U.S. Department of the Interior BUREAU OF LAND MANAGEMENT

Sundry ID: 2698966

Type of Action: APD Change

Procedure Description: OXY USA Inc. respectfully requests approved to amend the subject wells AAPD deep intermediate cement job to align with the agreed upon R111-P updates presented at the latest JITC meeting. See the attached updated cementing program and diagram for reference.

Figure C] 4 - String - Un Cemented Annulus

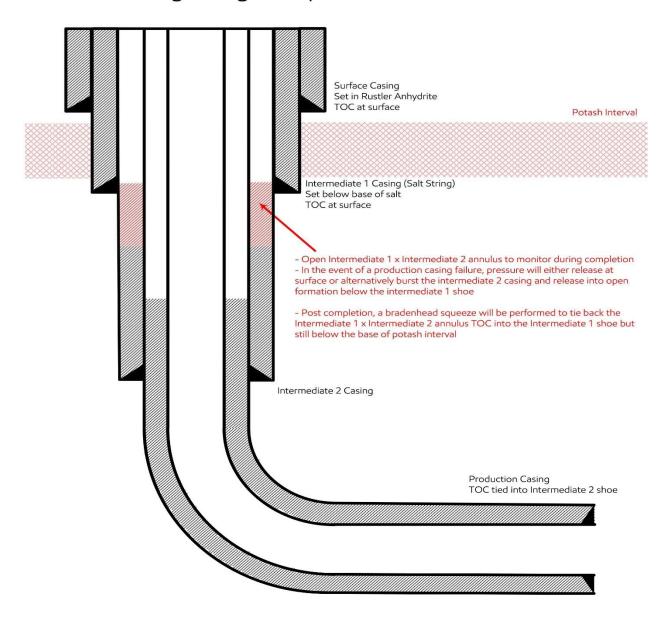
Oxy requests to update the Deep Intermediate Cement Job to align with the agreed upon R111-P updates presented from the JITC. (Below table based on Precious 30-18 Fed Com 175H)

ALL PREVIOUS COAS STILL APPLY. CEMENT DESIGN UPDATE AS PER KPLA BEST PRACTICES (4-STRING INT1 X INT2 OPEN ANNULUS)

Operator has proposed to pump down 7-5/8" X 9-5/8" annulus POST-FRAC.

Operator must top out cement after the bradenhead squeeze and verify cement to surface. Operator can also check TOC with Echo-meter. CBL must be run from TD of the 7-5/8" casing to surface if confidence is lacking on the quality of the bradenhead squeeze cement job. Submit results to BLM.
